Development Control Committee B – 18 March 2020

SITE ADDRESS: The Marchioness Building Commercial Road Bristol BS1 6TG

APPLICATION NO: 19/01925/F

DEADLINE: Reinstatement of historic landing stage for use associated with Marchioness site (revision to 17/03268/F).

PROPOSED FRONT ELEVATION (A - A')

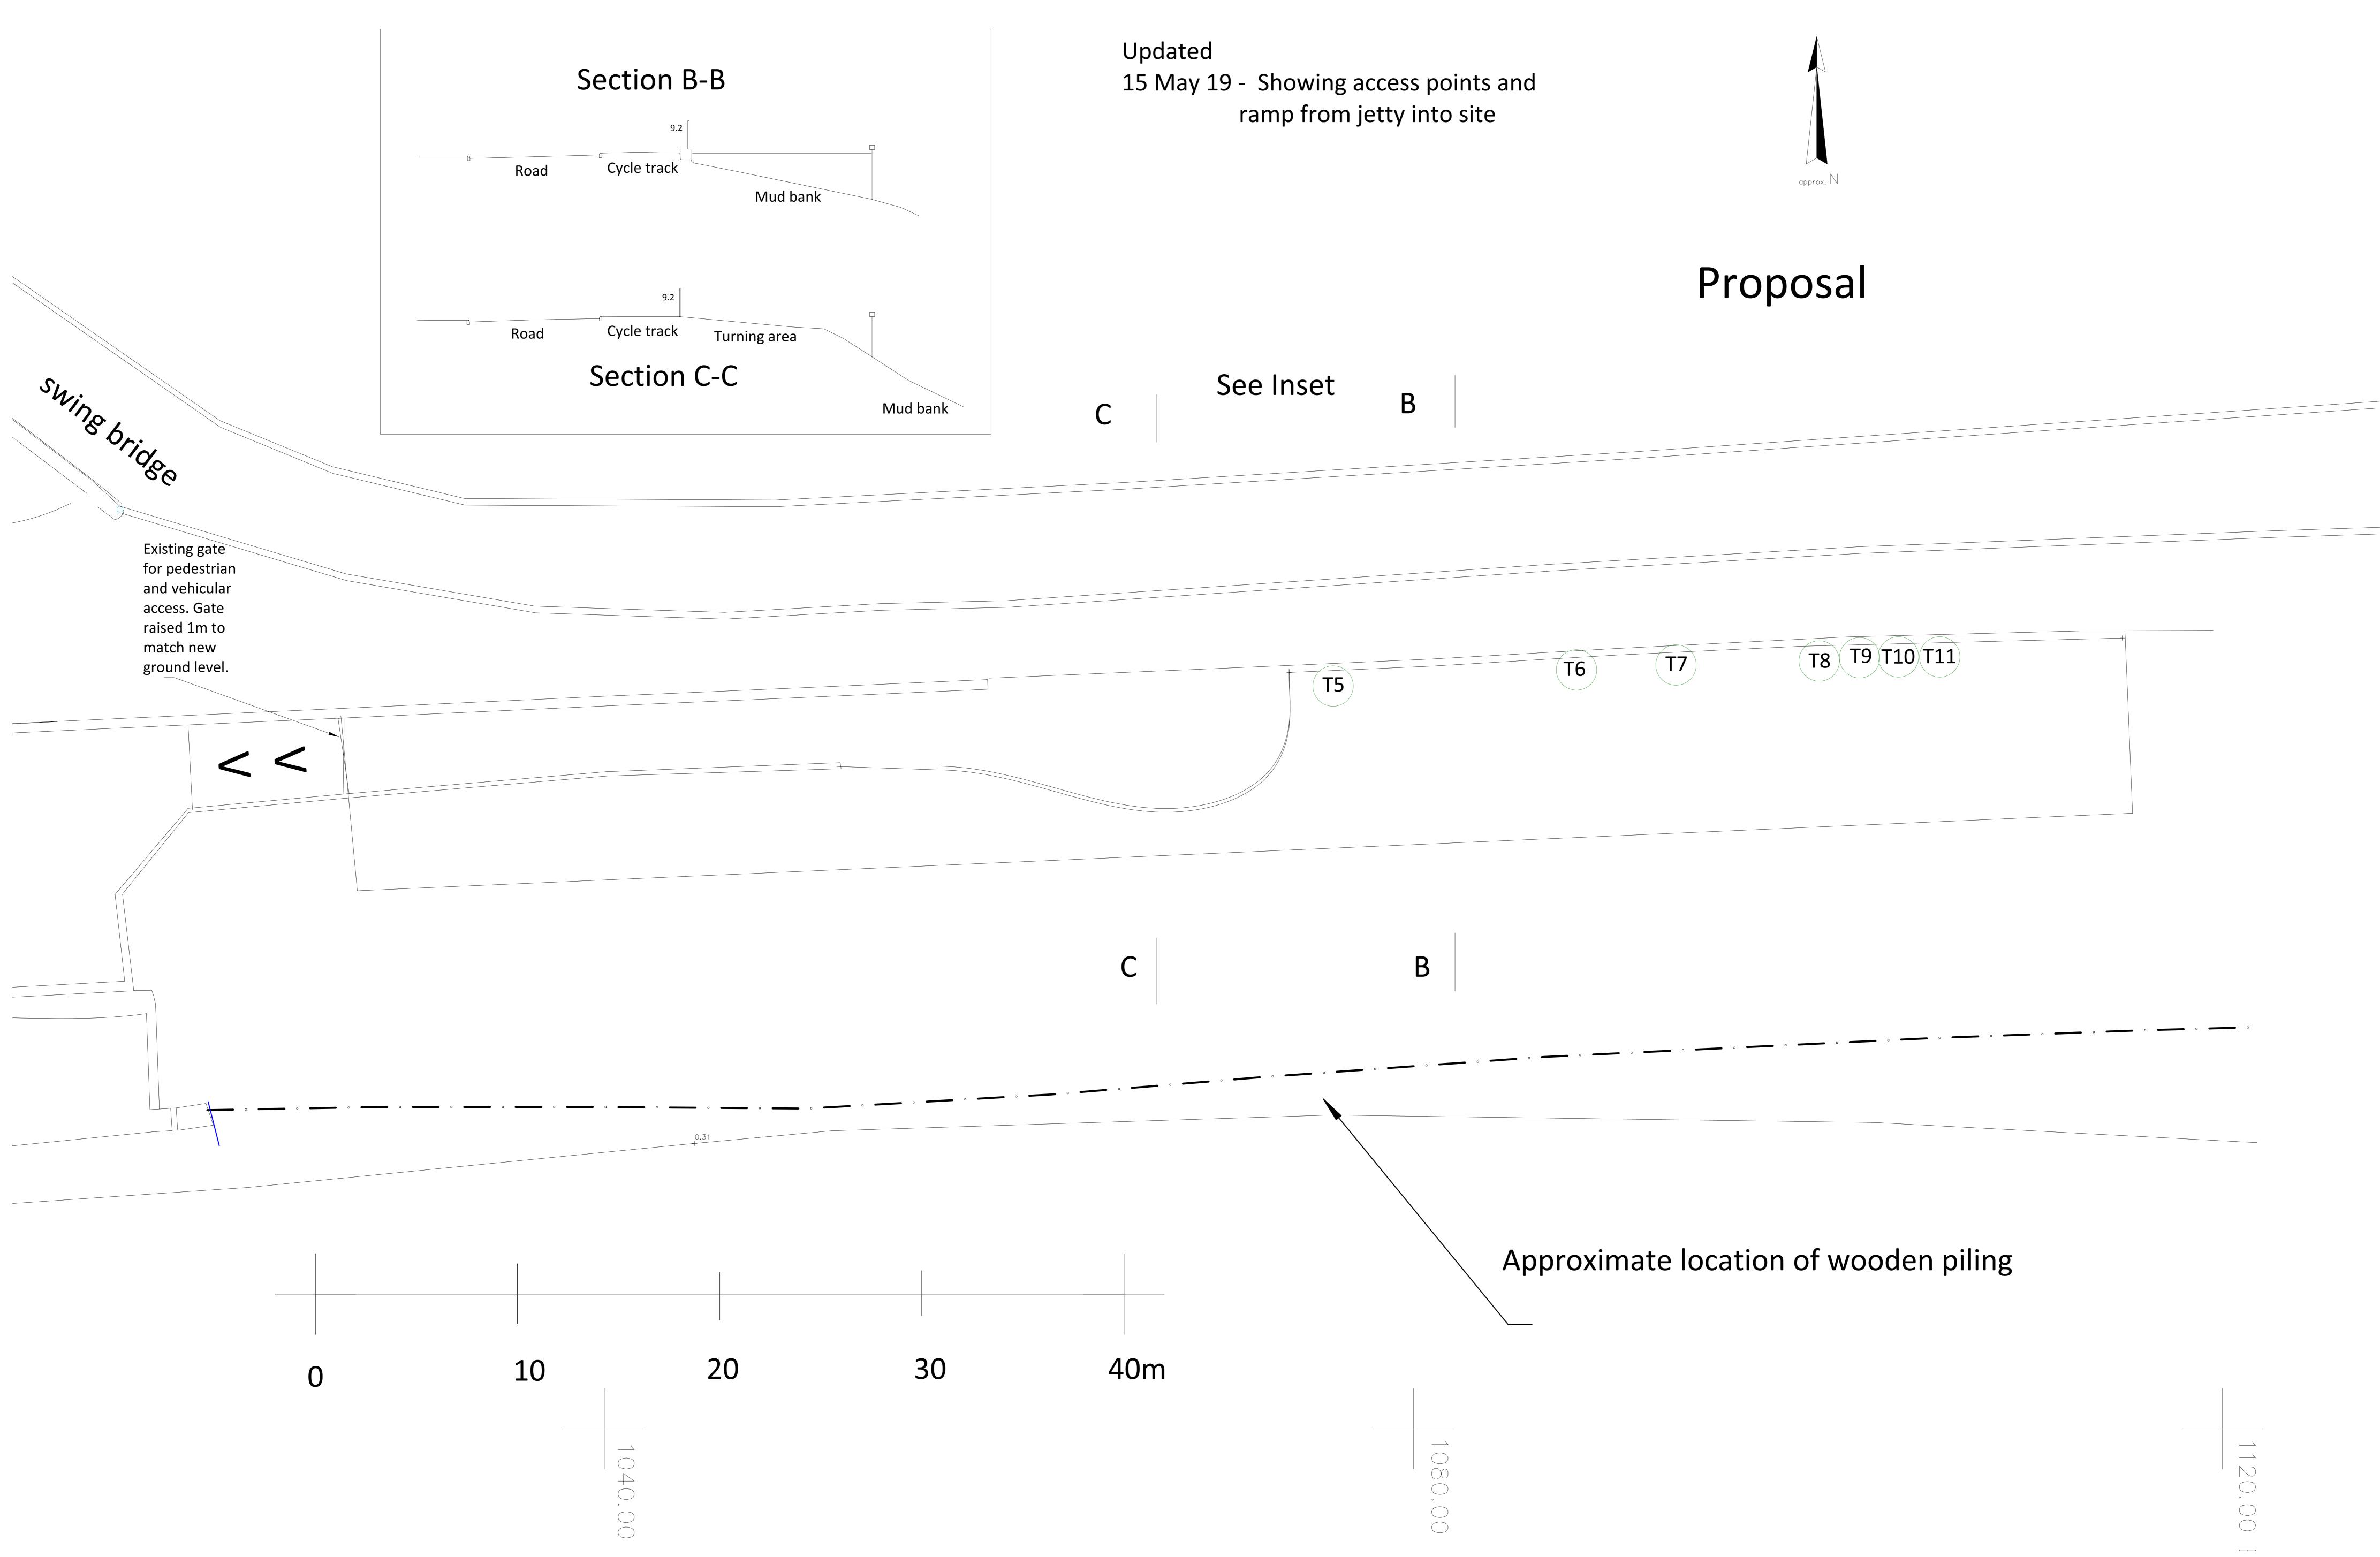
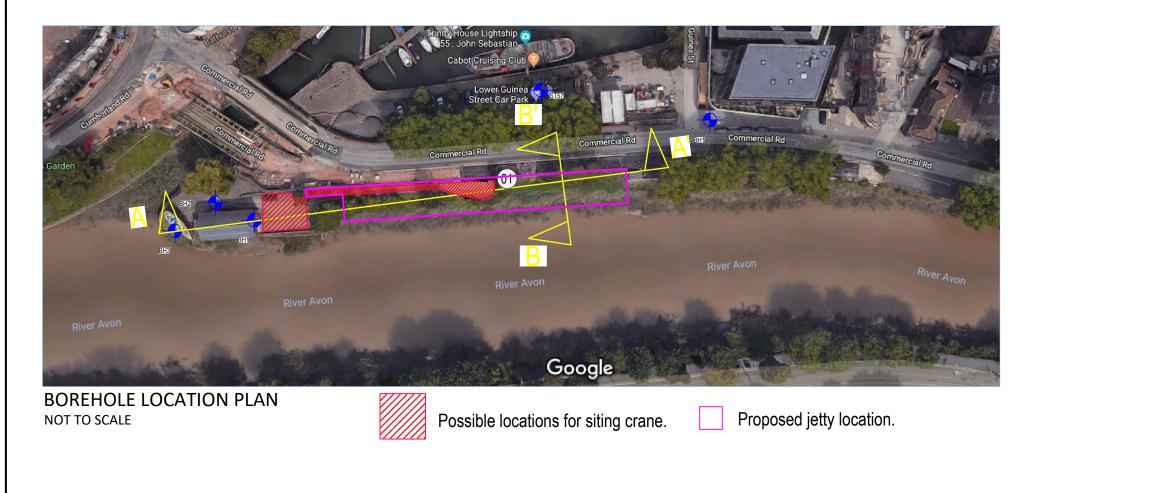
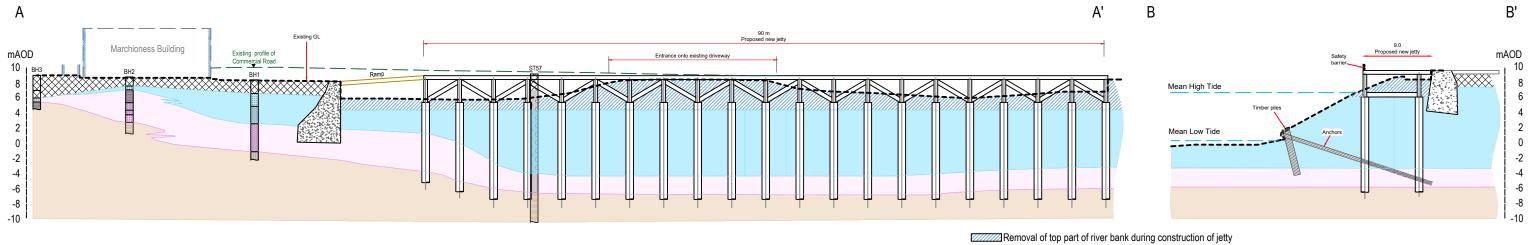
The two easternmost possible locations for siting the crane shown on the borehole location plan are located on the designated Site of Nature Conservation Interest (SNCI), River Avon (part of). I object to this planning application because these two locations are contrary to Policy DM19 in the Local Plan. Using only the westernmost location would address this objection.

The nature conservation officer has reviewed the submissions and objected to the application due to two of the potential locations for the crane shown on the borehole location plan as these are located on the designated Site of Nature Conservation Interest (SNCI), River Avon. Using only the westernmost location would address this objection. There are fundamental objections to the proposal as outlined above and significant uncertainty in the proposed design, given the need for significant site investigations and risk assessments. The applicant is advised to address the objection and other matters raised by the Nature conservation Officer in event of any resubmission.
